— PLANNING AND ZONING COMMISSION —

May 12, 2020
6:00 P.M.
City Council Chambers

Agenda Item: 7.C. Consider recommendation on request for approval of a Preliminary Plat for Ashton Park Plat 7.

ASHTON PARK PLAT 7
 INDIANOLA, IOWA
DRAINAGE MAP

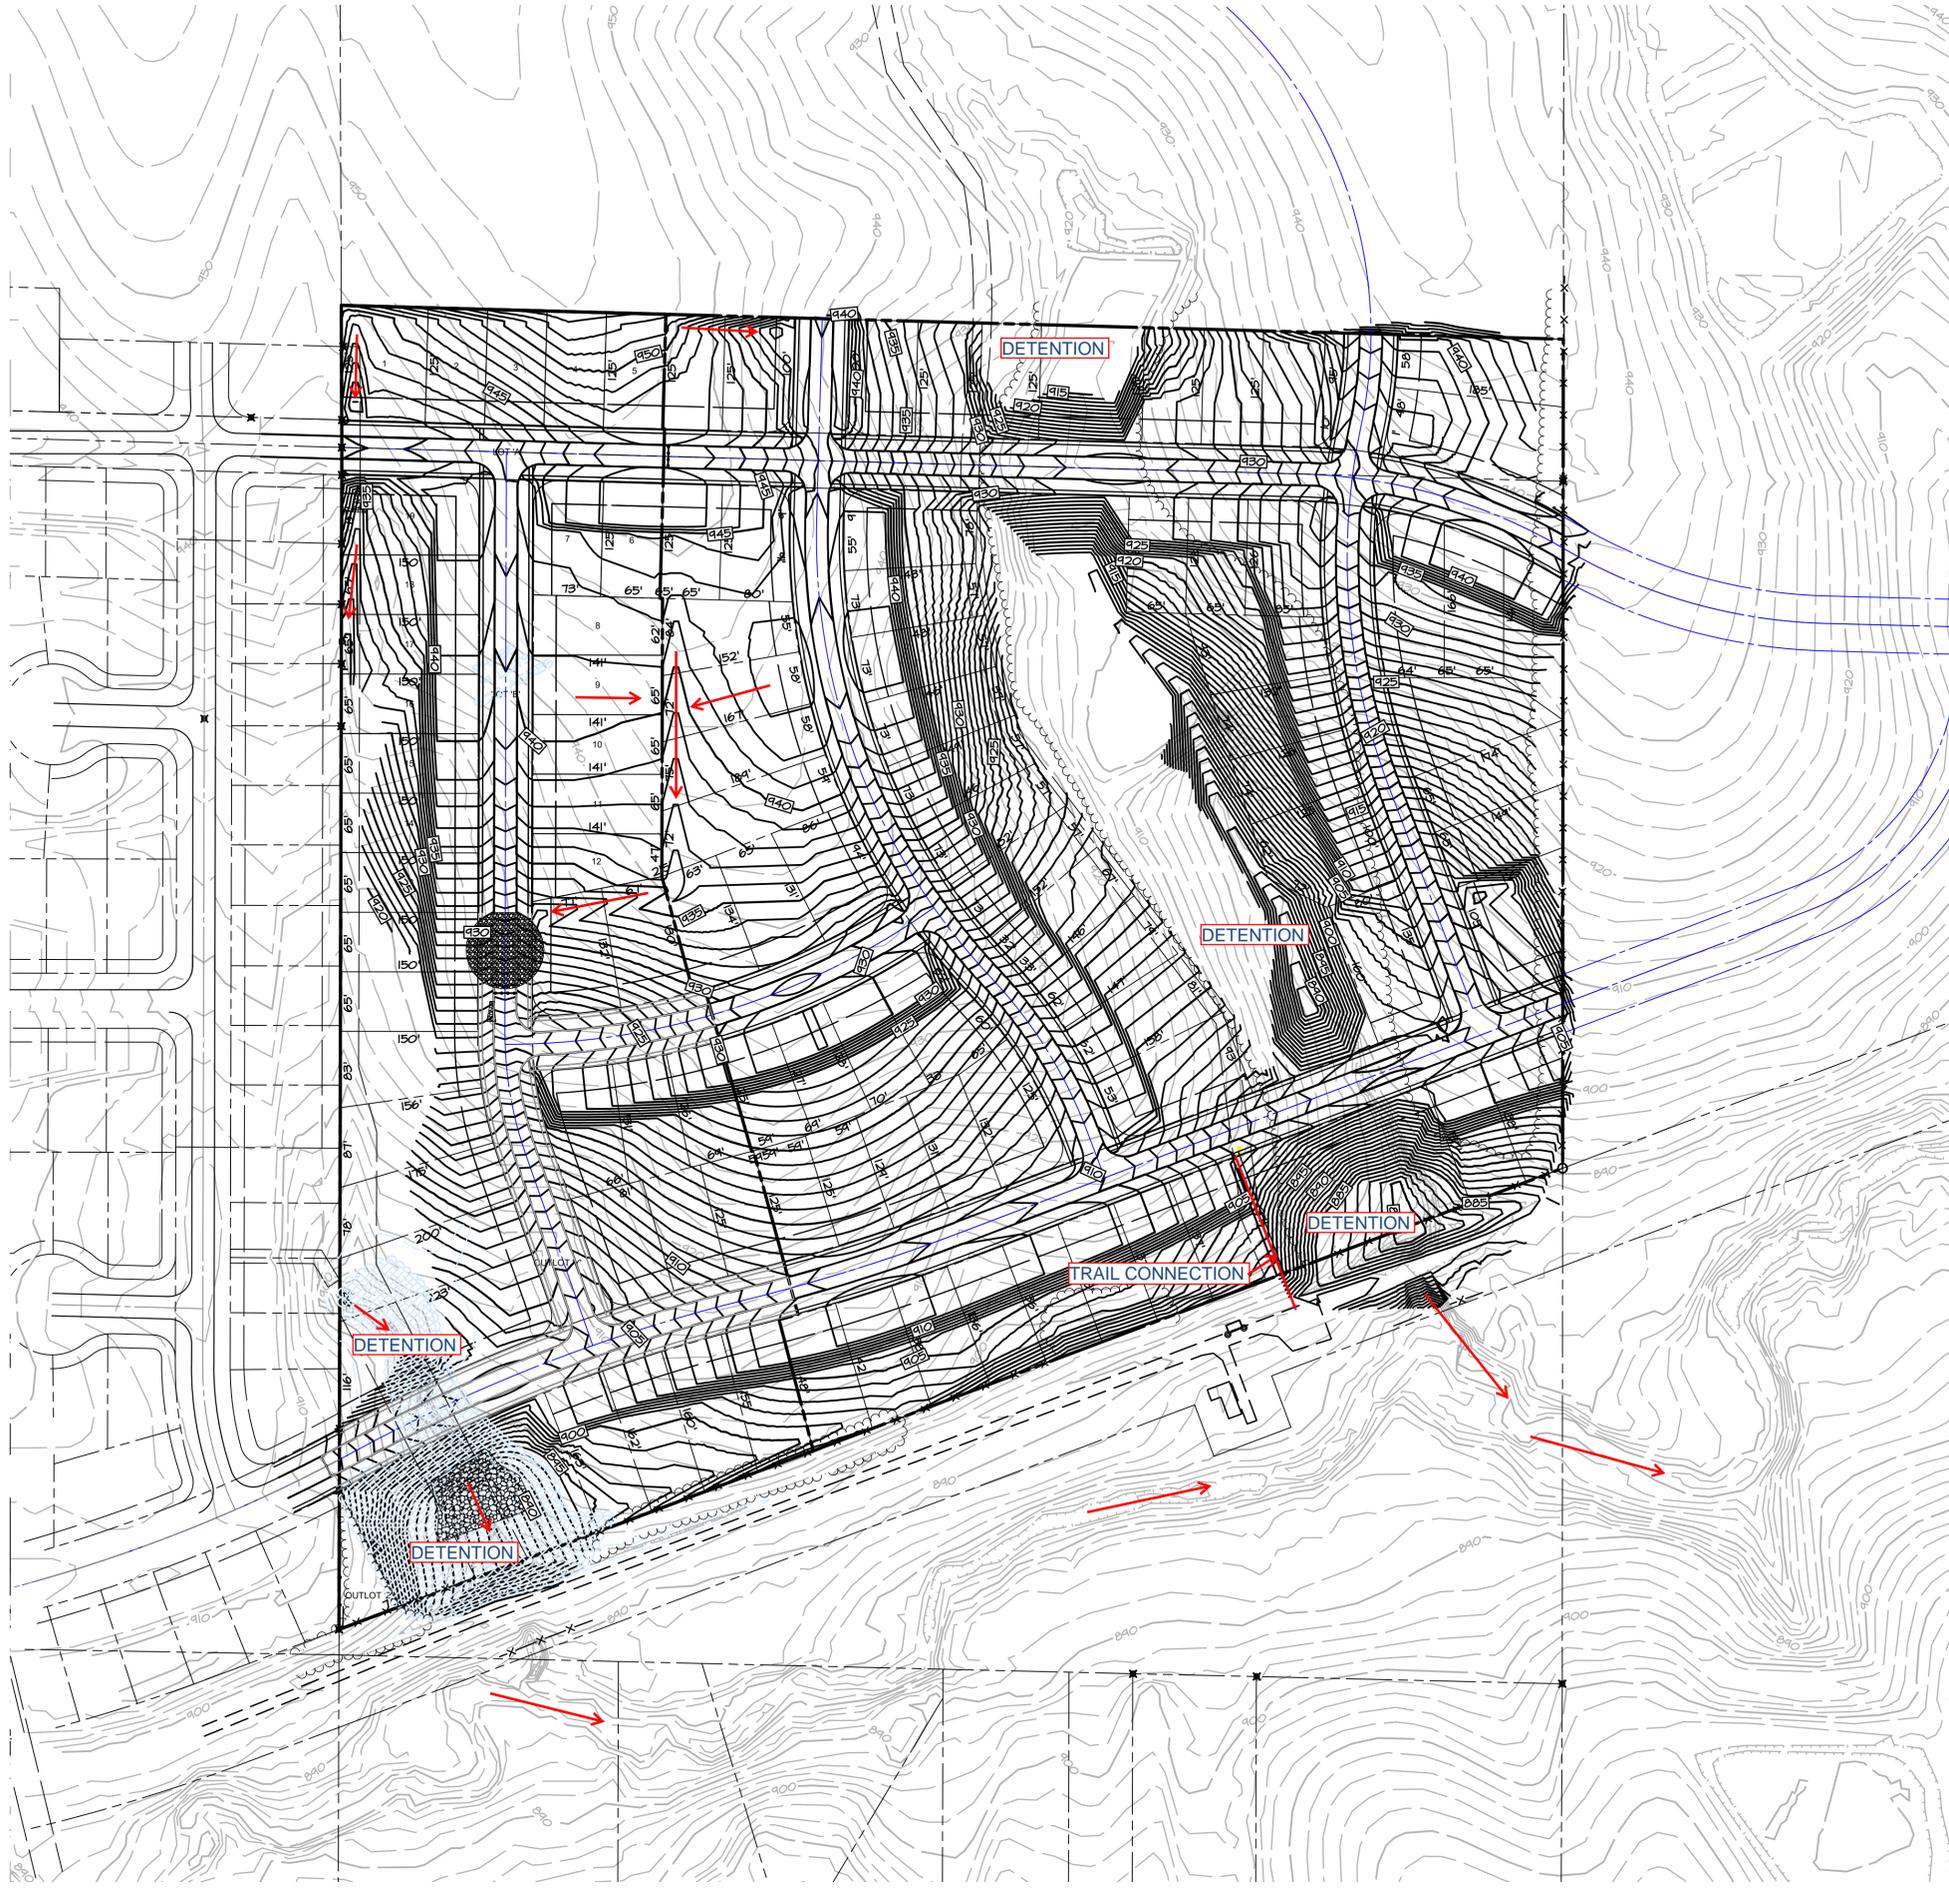
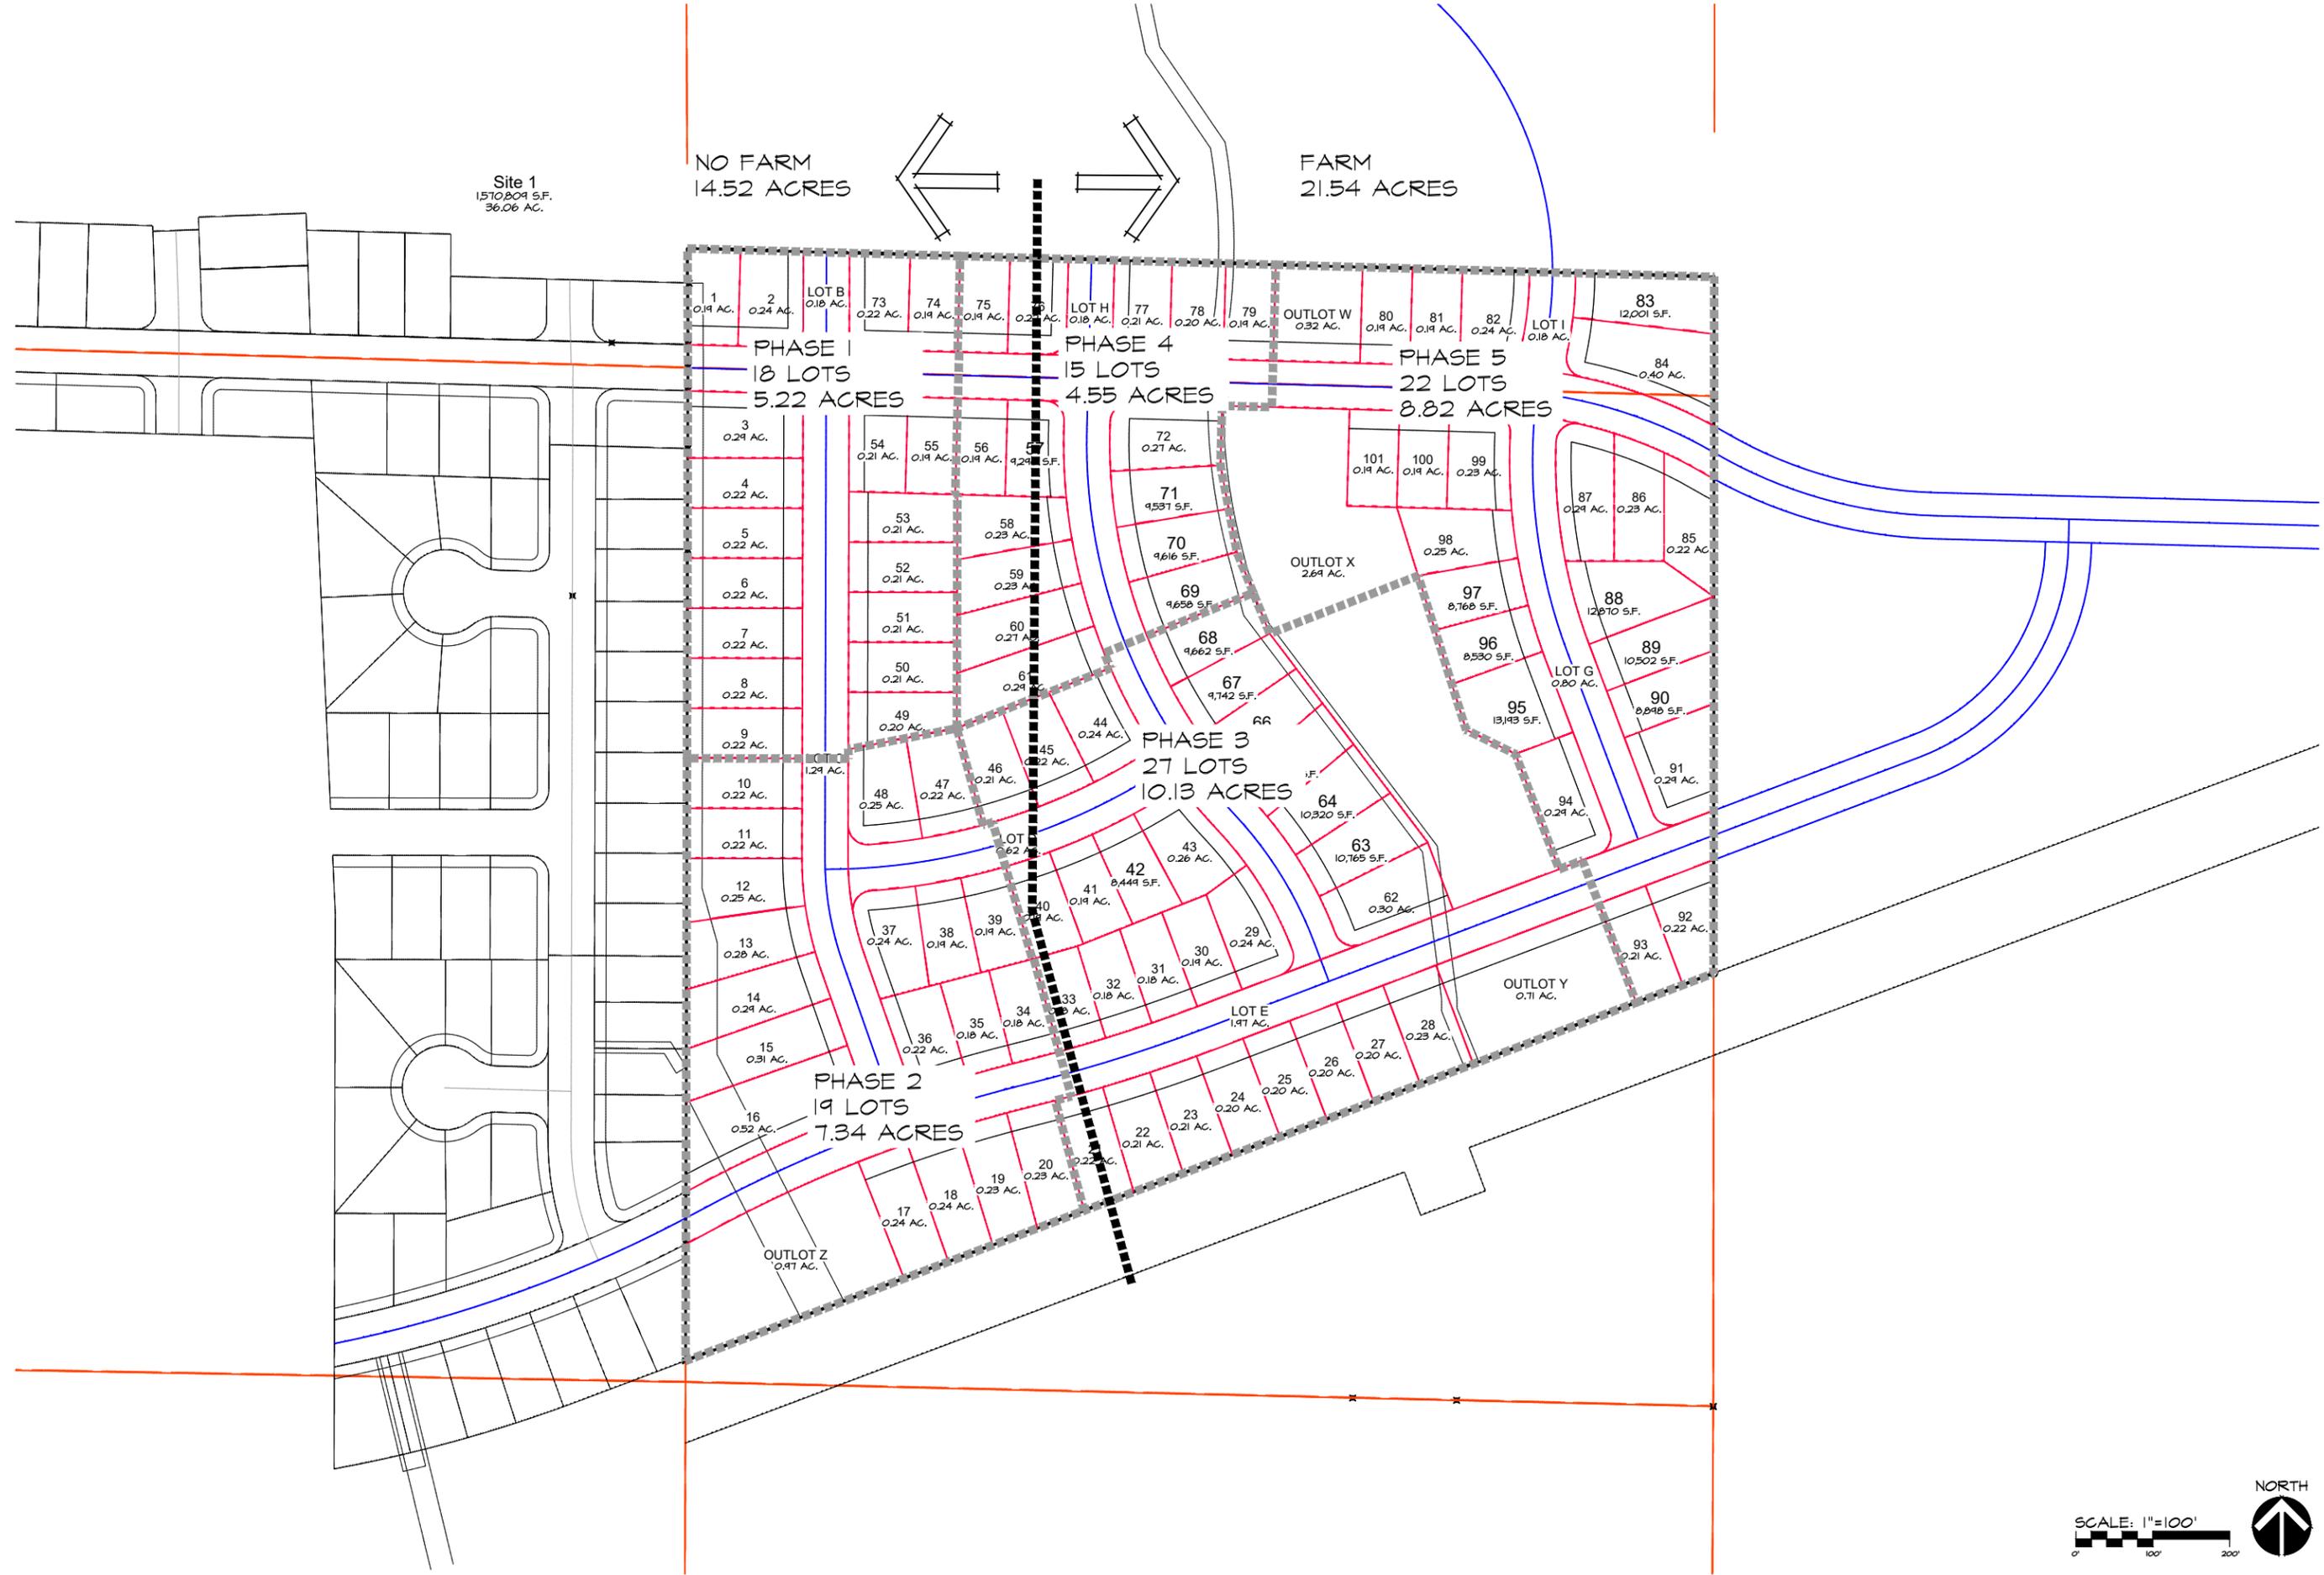
4. There is significant drainage area north of Euclid Avenue and needs to be routed through the proposed 36" storm sewer at the northeast corner of the plat. Calculation of the 100-year storm elevation should be calculated with consideration of the necessary grading plan, such that lot 1 will not be impacted or lot 16 of Ashton Park Plat 6. **Channel and weir calculations have been added to the SWMP and we have provided a catastrophic flow route that goes to the low point intakes on E. Euclid Avenue. We will require a minimum opening elevation on this lot and any other lot that would potentially be affected by stormwater flowage. This documentation will be provided with the construction drawings and final plat.**

An overall grading plan for the entire 36.06-acre parcel was emailed to you on 5/5/2020. This shows our future plans to expand the detention area (Outlot 'X', Plat 8). The pipes between the ponding areas will not be connected so that additional detention can be provided south of Boston Avenue. We have extended the riprap to the flowline of the existing 60" culvert as requested.
